### UDPRP Review Summary 03.22.13

Urban Design Peer Review Panel

PROJECT: Flora Lofts

## 2121 Flora St.

# FLORA STREET FRONTAGE ZONE

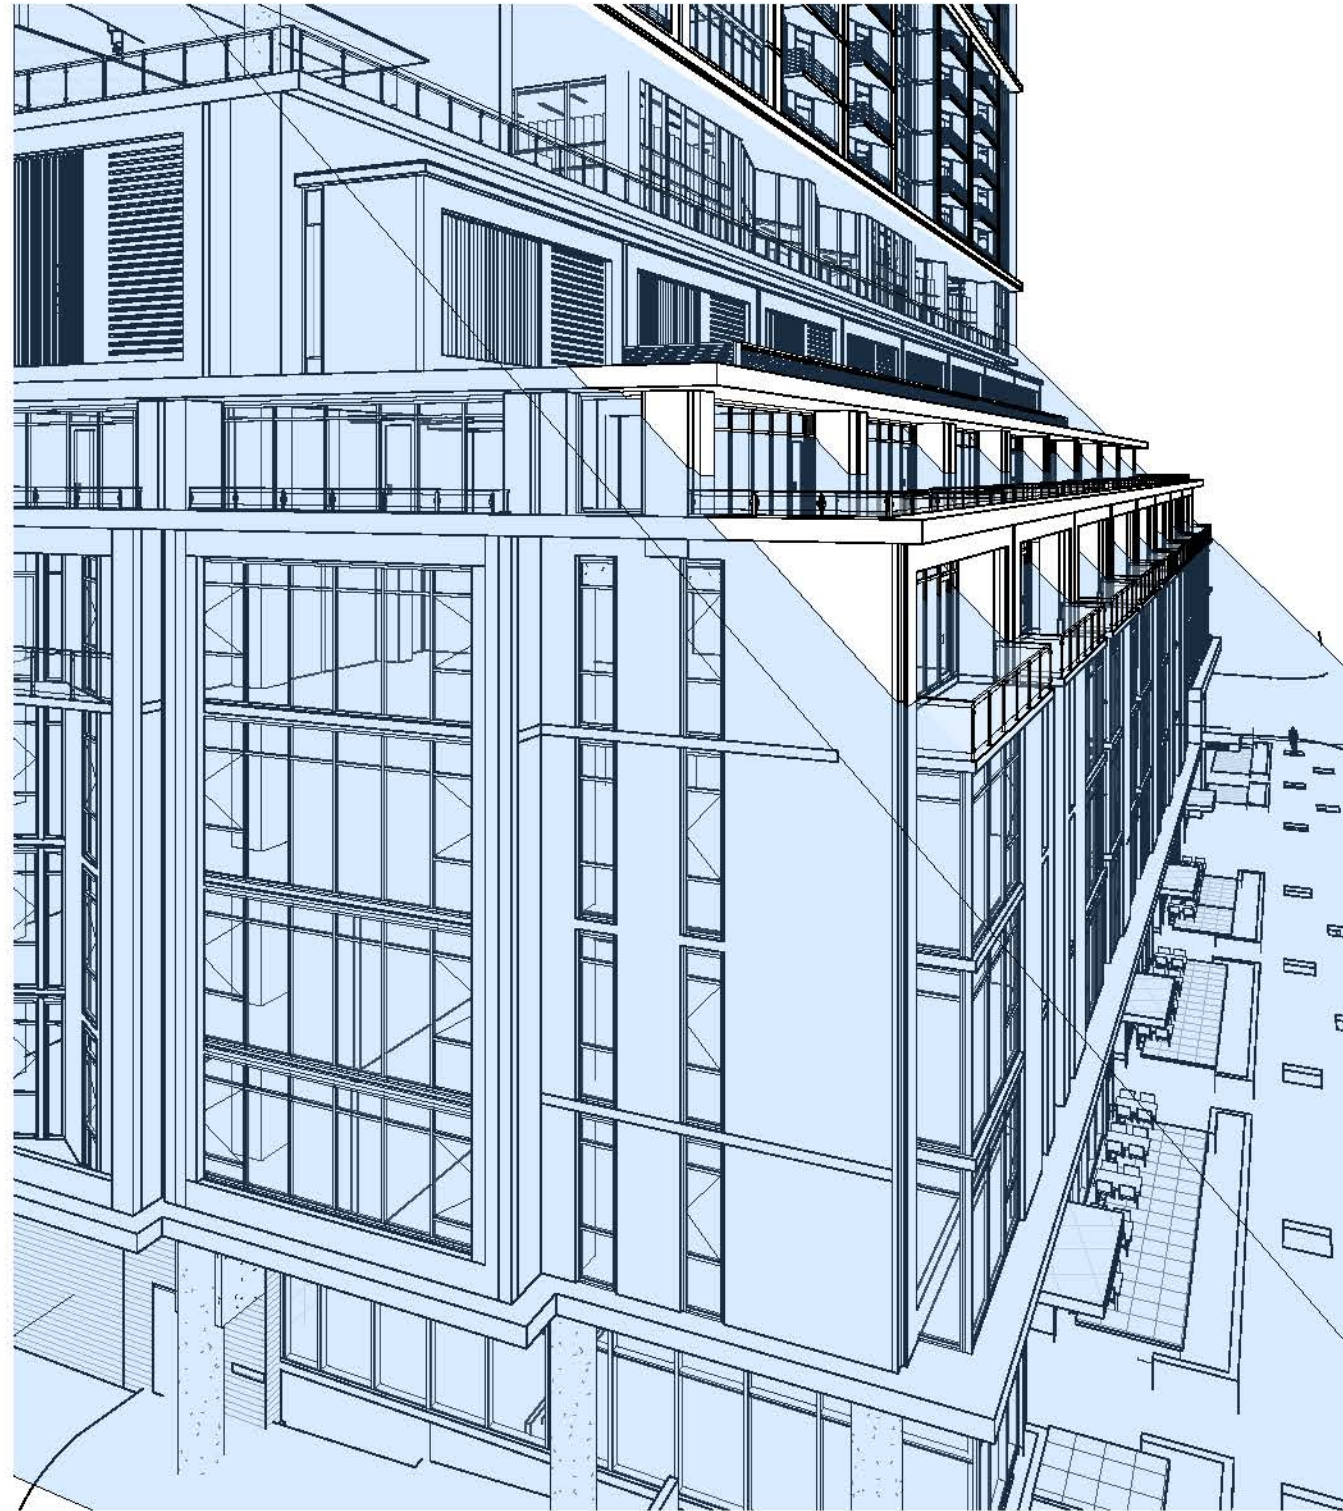
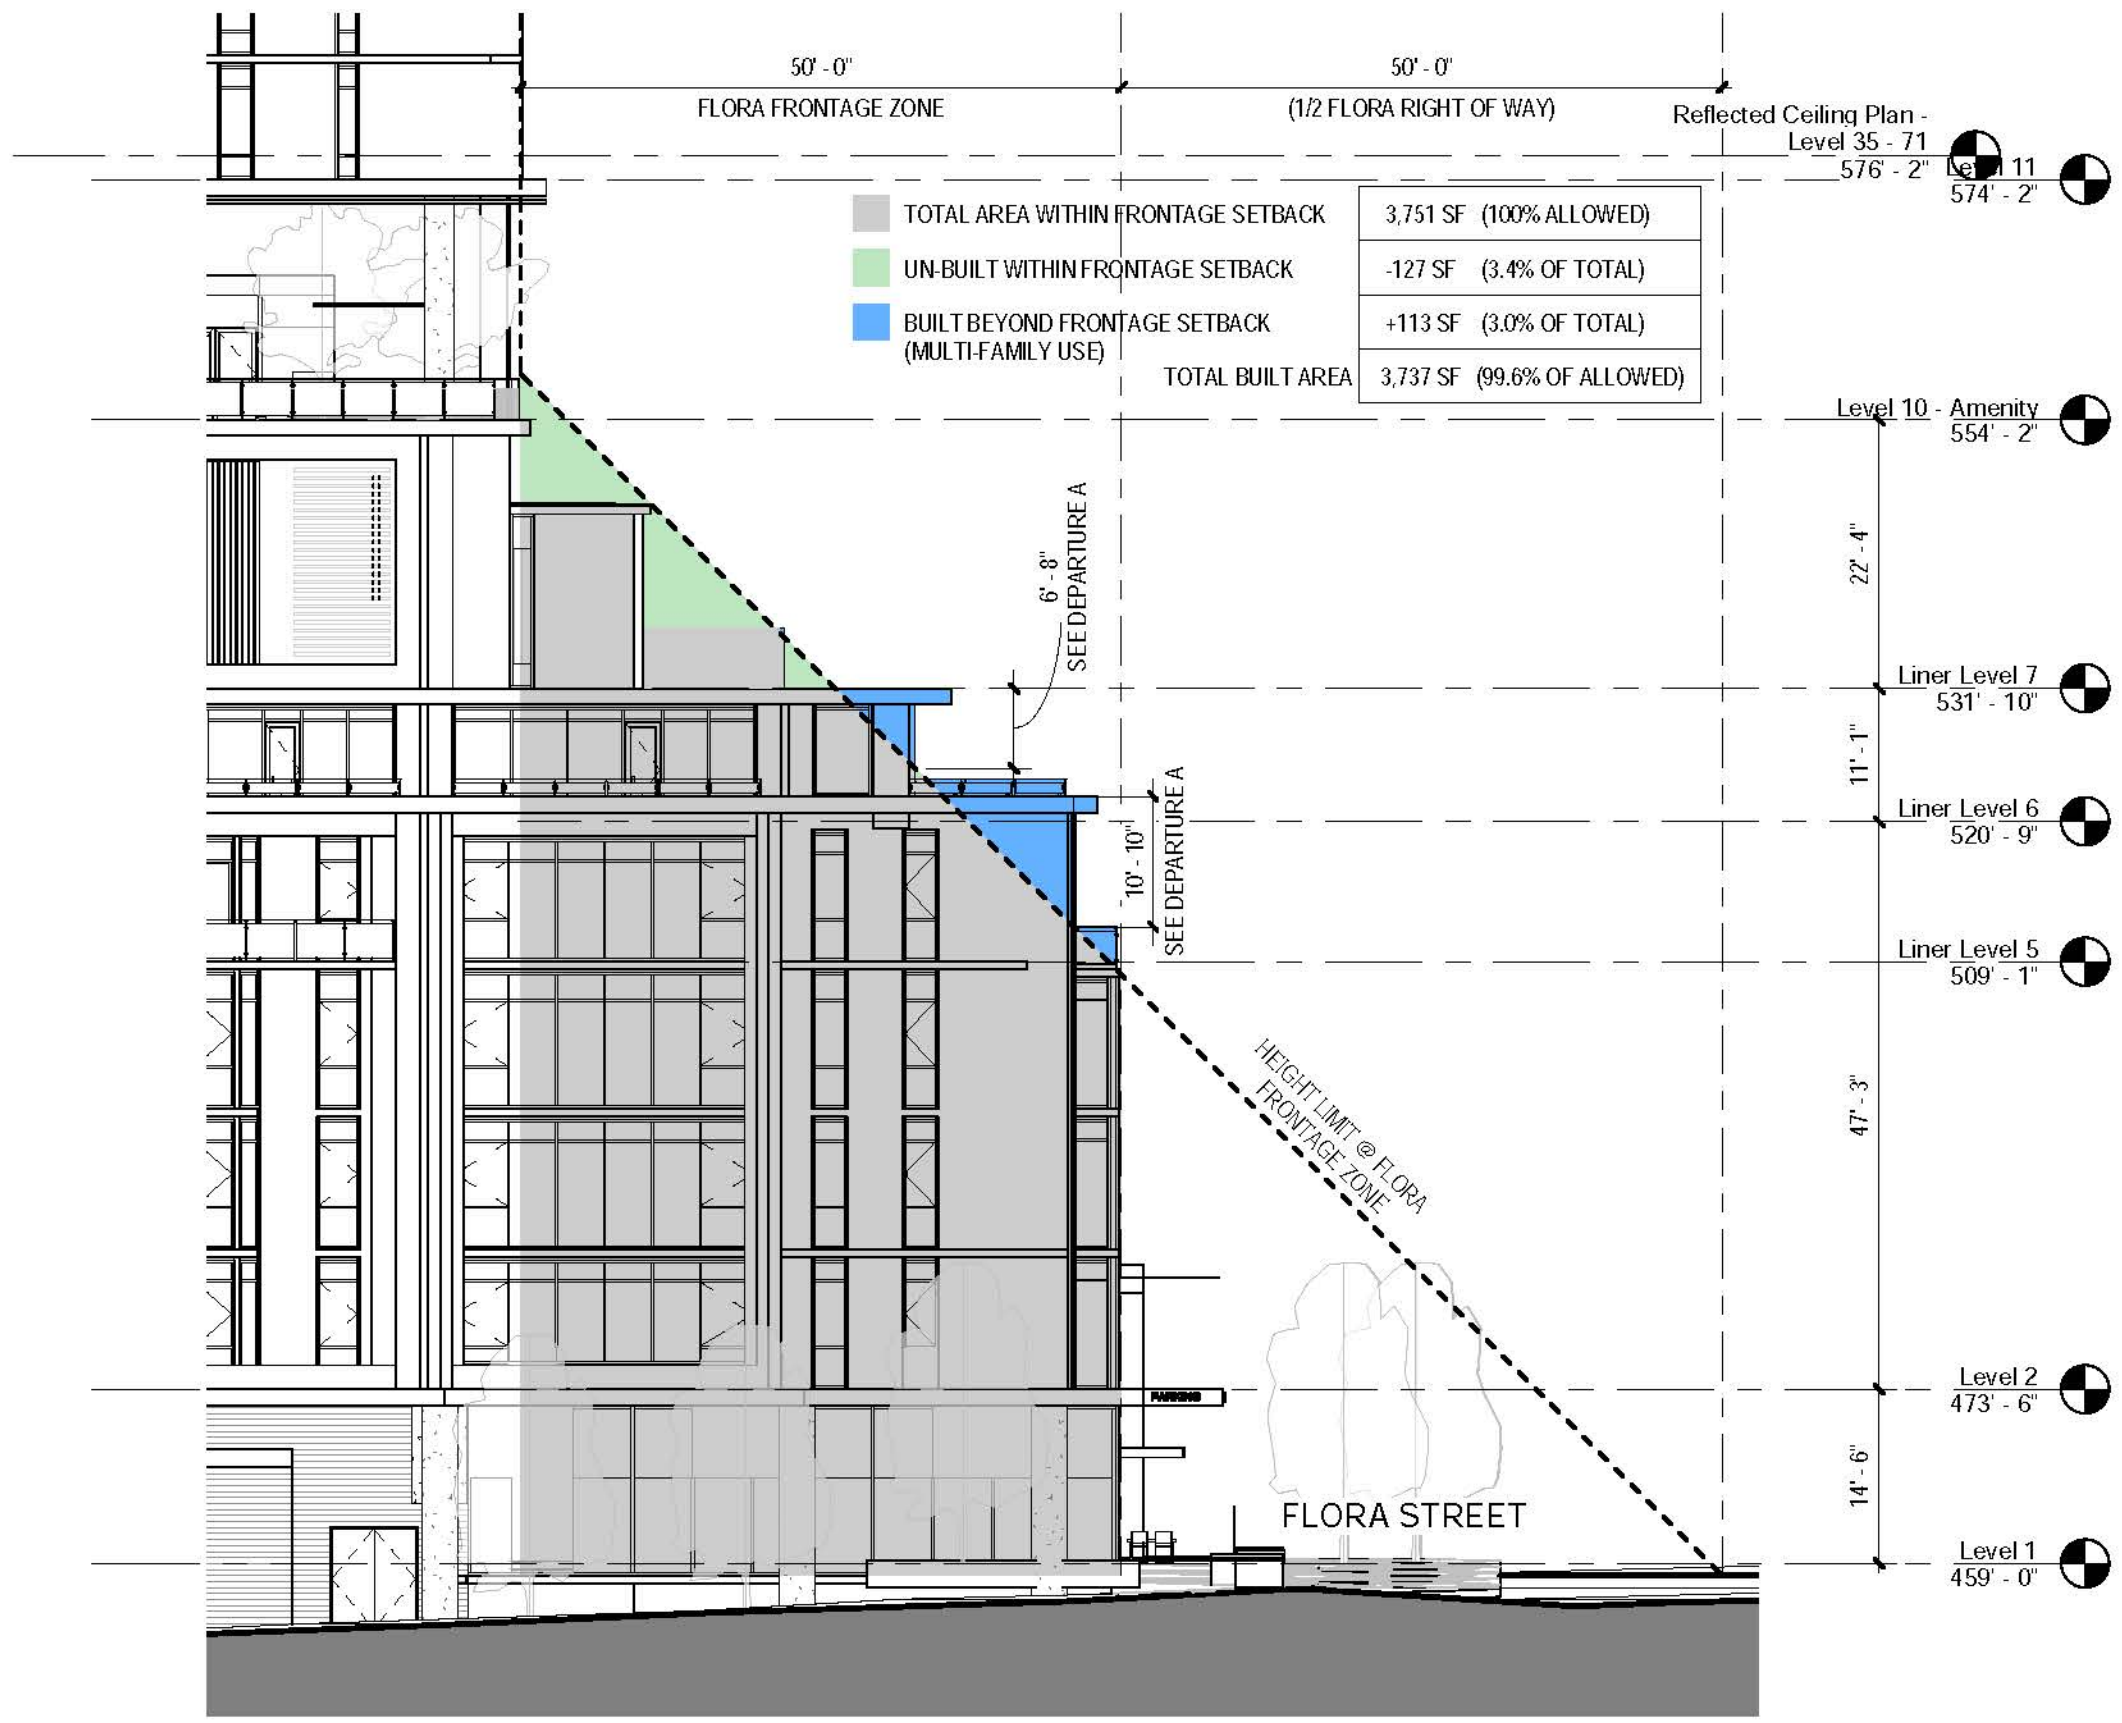
- [2] Grade changes along the Flora sidewalk frontage should be negotiated in a way that avoids significant barriers between sidewalk patios and throughway zone, thus maximizing the flexibility of the space -

Permanent landscape barriers should be avoided in the Flora streetscape. Public realm treatment should maximize flexibility of uses and arrangements of the space.
